Design Review and Post-Earthquake Assessment

Horowhenua District Council Building

126-148 Oxford St, Levin

Reference: 2788-8773

Diagram 12

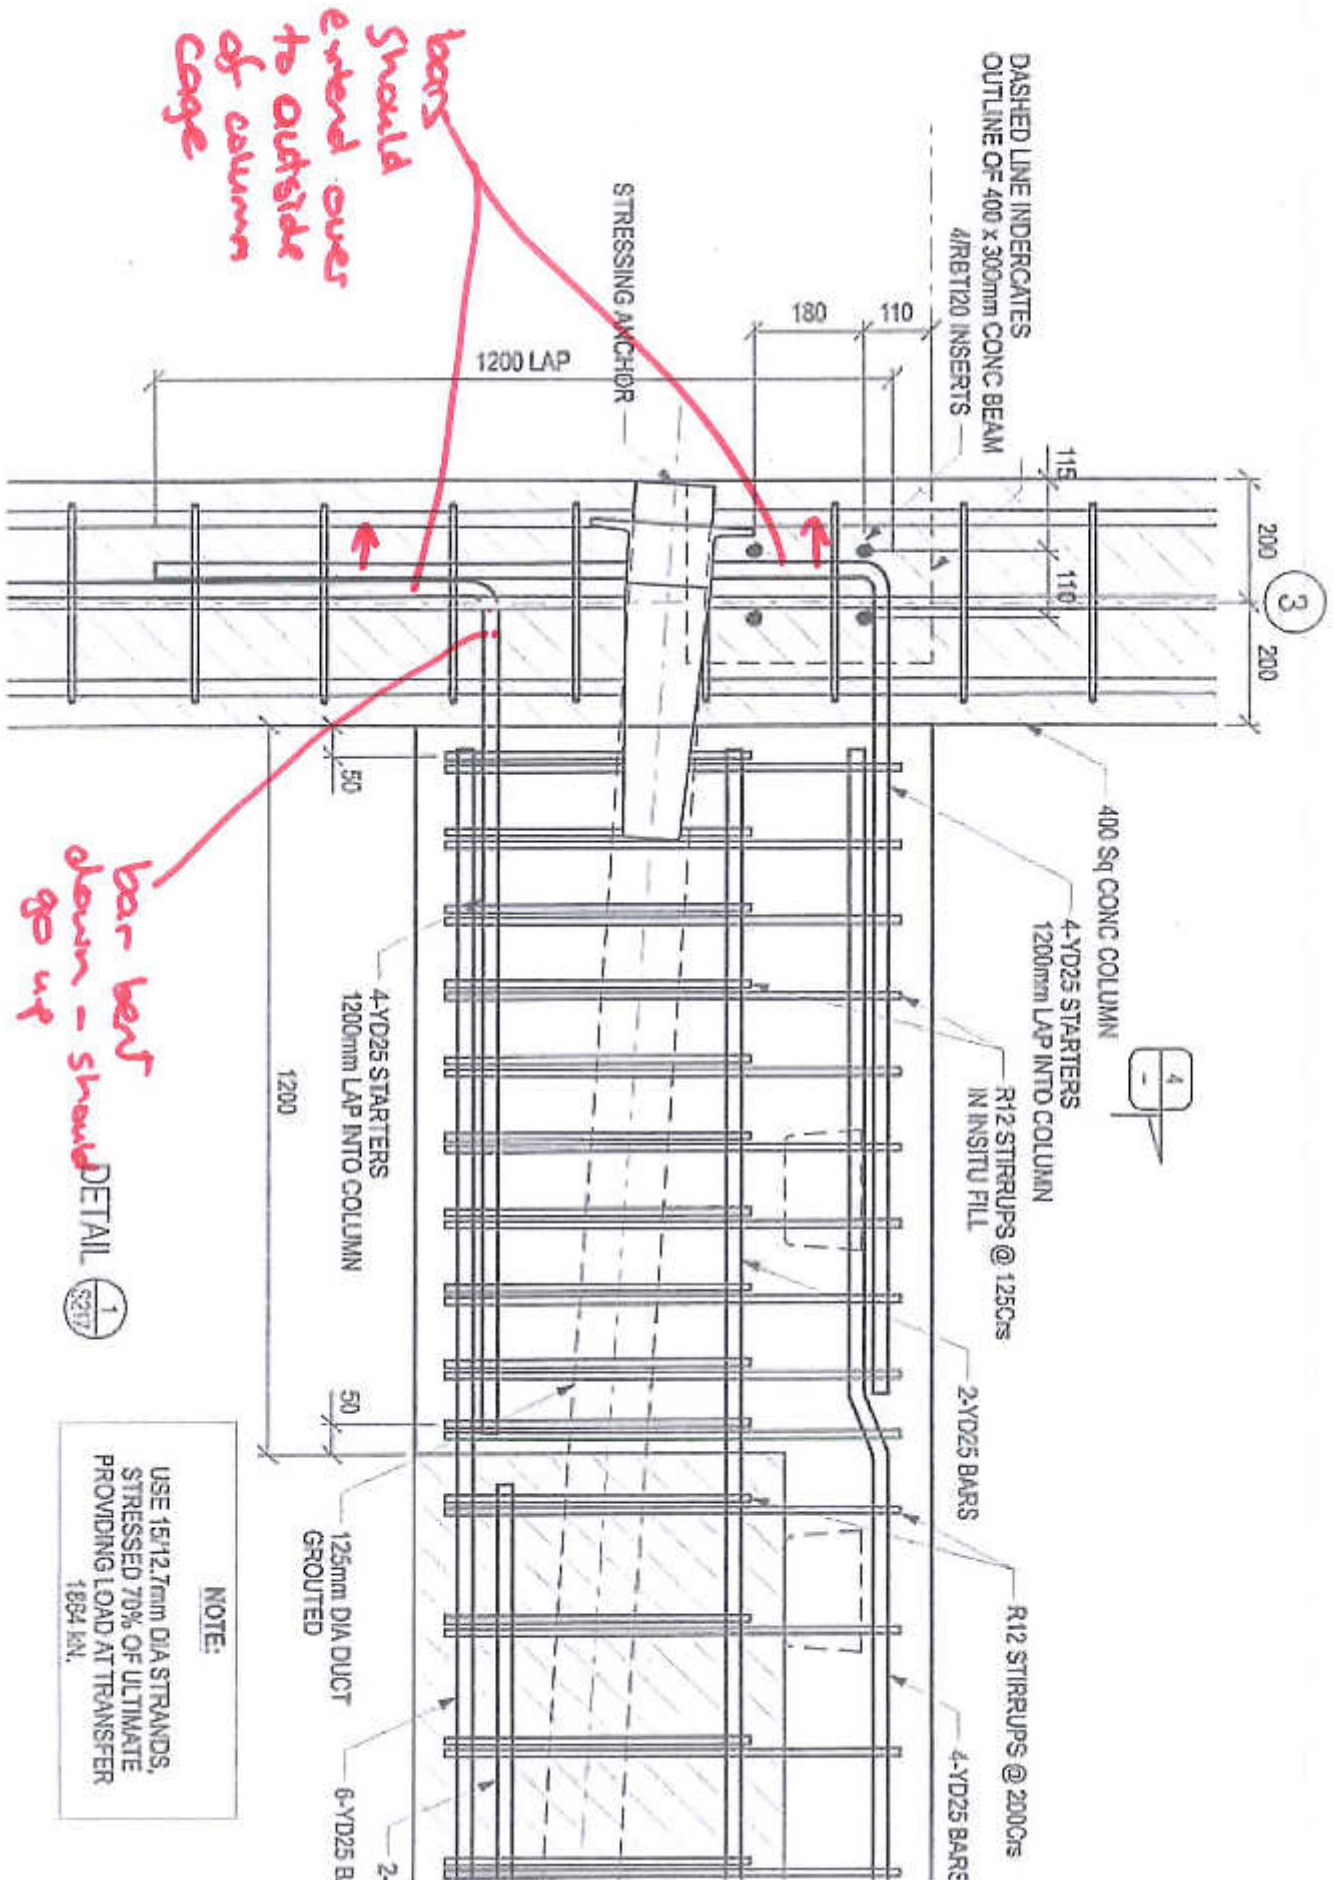
Bar termination at mezzanine floor level of beams to columns does not comply with NZS3101. To engage the joint and provide continuity the bars should extend to the far face of the column and terminate by bending the bar up if it is the bottom bar and down if it is the top bar. The arrangement used will limit the capacity of the reinforcing to be engaged at the joint and therefore capacity at the system to act as a frame. (See appendix A, Diagram 11 & 12)

Diagram 14

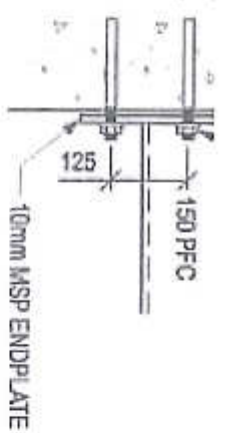
The mezzanine floor diaphragm has large openings which will limit the ability for it to act as a diaphragm between grid E and N. Also the concrete beam on grid 3 has limited reinforcing and lacks the capacity to act as a chord member for the diaphragm. There does not appear to have been any attempt to deal with the potential high stresses that will occur around the openings. (See appendix A, Diagram 13 & 14)

Diagram 15

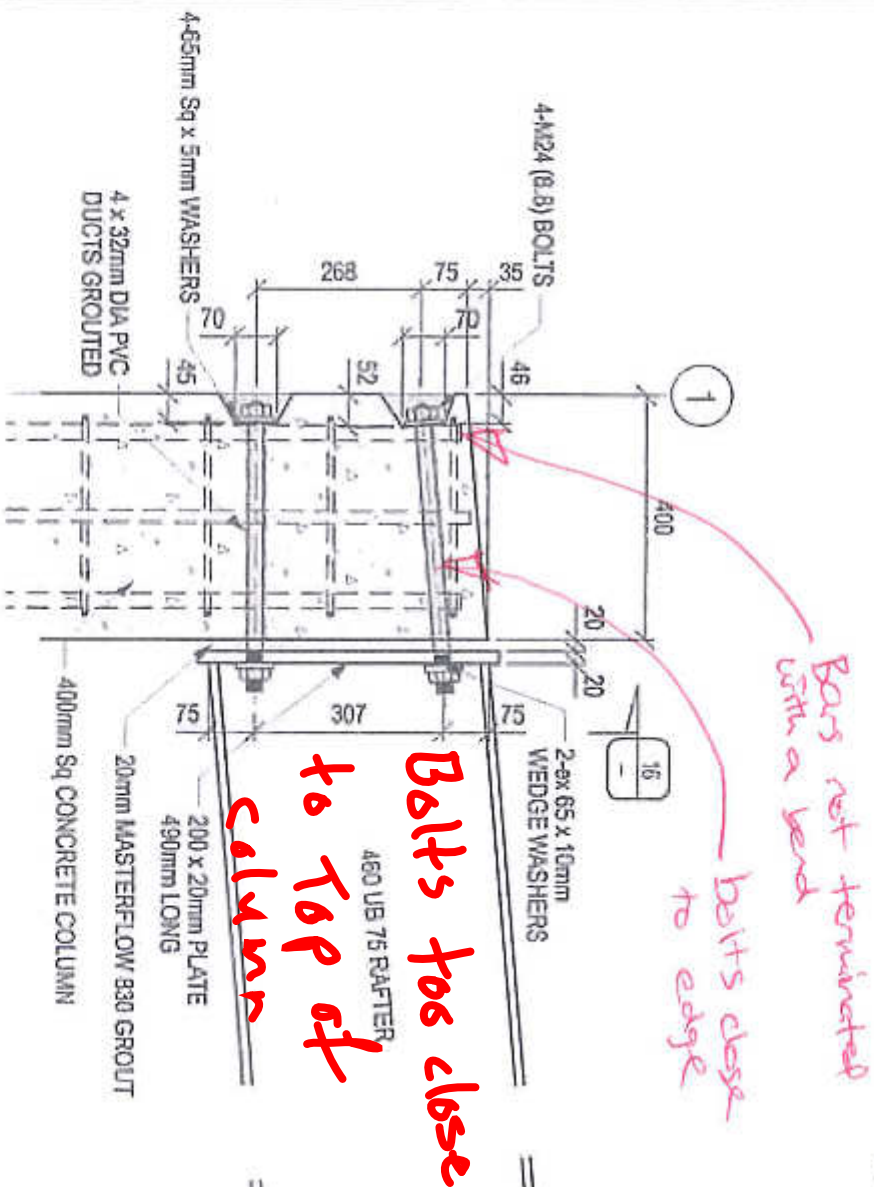
The current detail on grid 1 between will not support continuity for two reasons. The first being the fact the bolts are very close, 75mm, to the top of the column and likely to bust out under significant load. The second is that the reinforcing terminates as a straight bar with no bend hence the development of the bars cannot be achieved and full capacity not available. (See Appendix A, Diagram 15)

Diagram 17

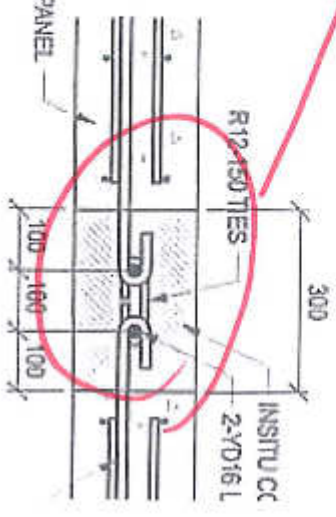
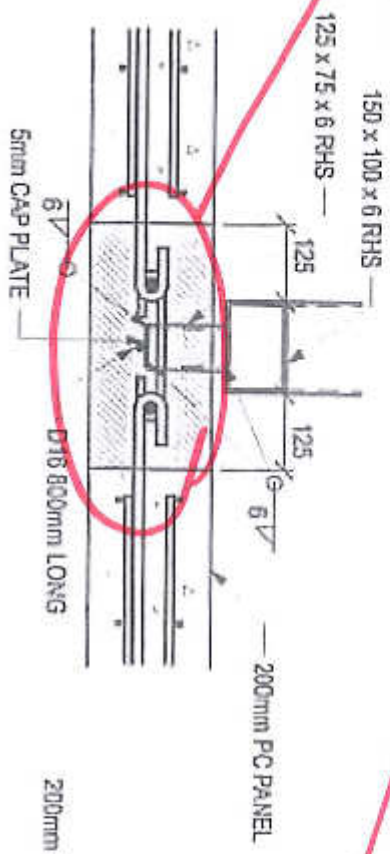
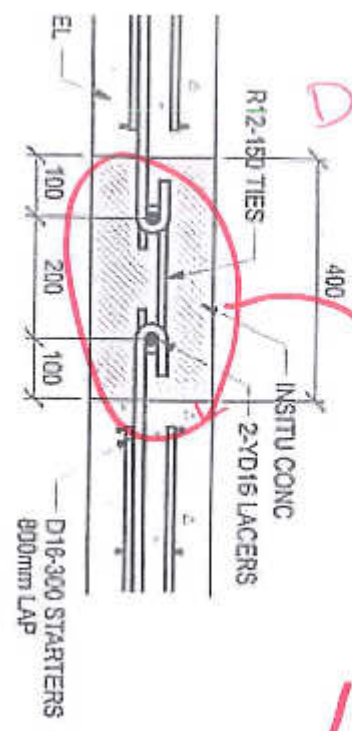
There is no indication in the calculations that any consideration has been made regarding out of plane support of the large spandrel panels at the centre of the wall line. There are significant forces to be resolved in this area that are complex due to the lack of a simple load path being available. Furthermore the waler does not have the strength or stiffness to satisfactorily deal with the loads from this panel.

The insitu stitch in this area will hinge and not provide continuity as the bars do not lap but link which will cause a hinge effect as opposed to continuity.

It is unlikely this area complied with the compliance documents at the time. (See Appendix A, Diagram 16 & 17)

Diagram 18

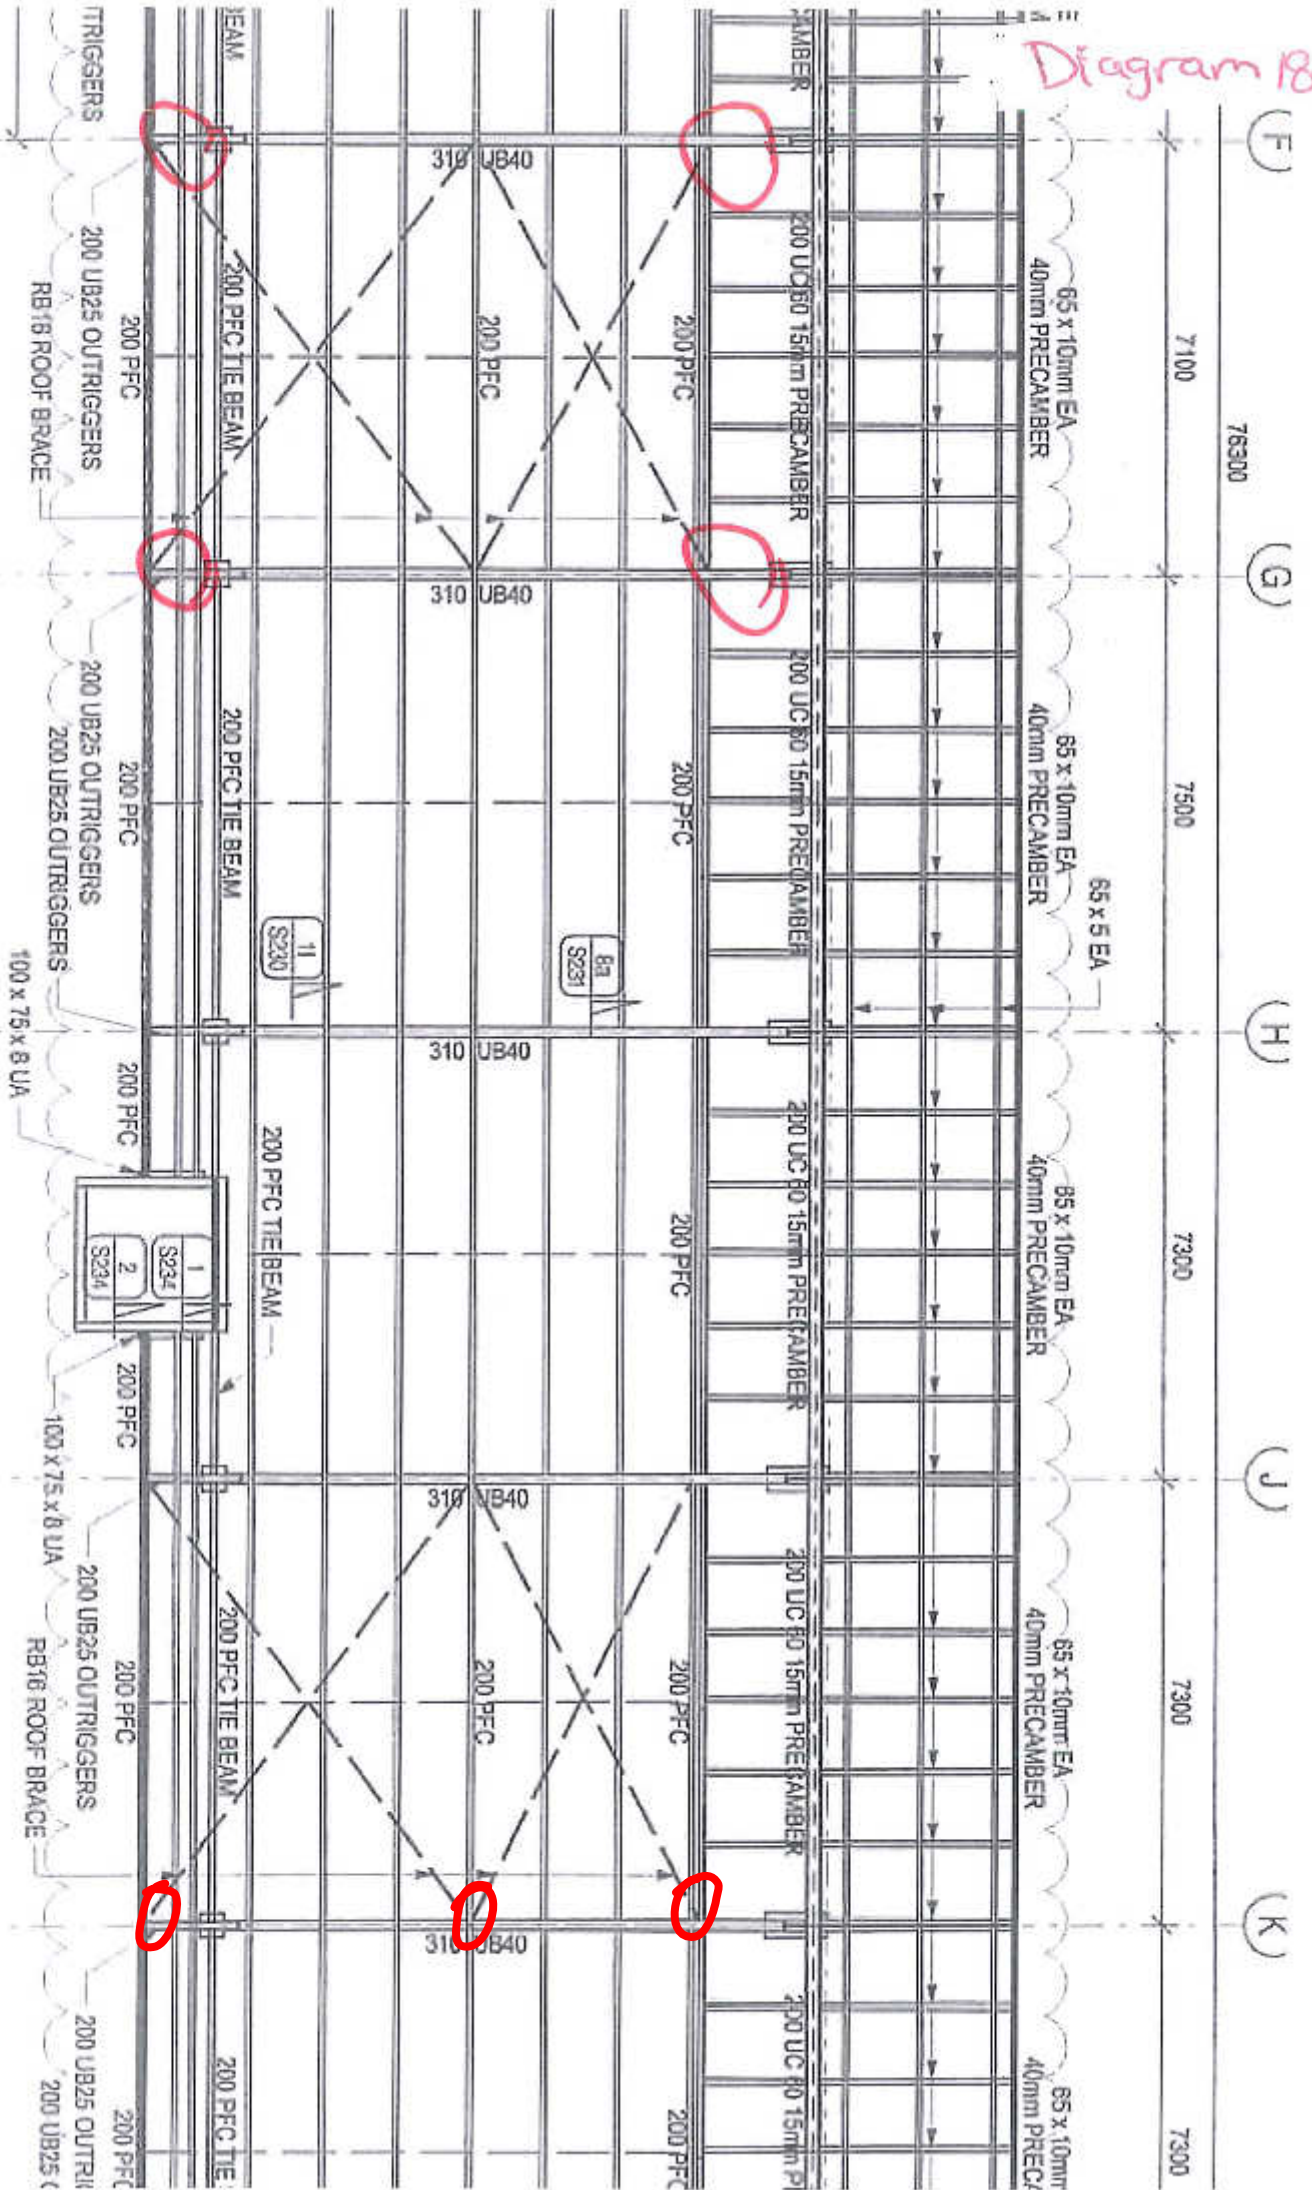
The bracing at the high level between grids E and L have design issues due to the bracing being terminated away from the vertical brace element on the rafter. This will cause secondary stresses on the beams in their weak direction and becomes the governing strength of the system which has strengths less than that required by the compliance documents at the time. (See Appendix A, Diagram 18)
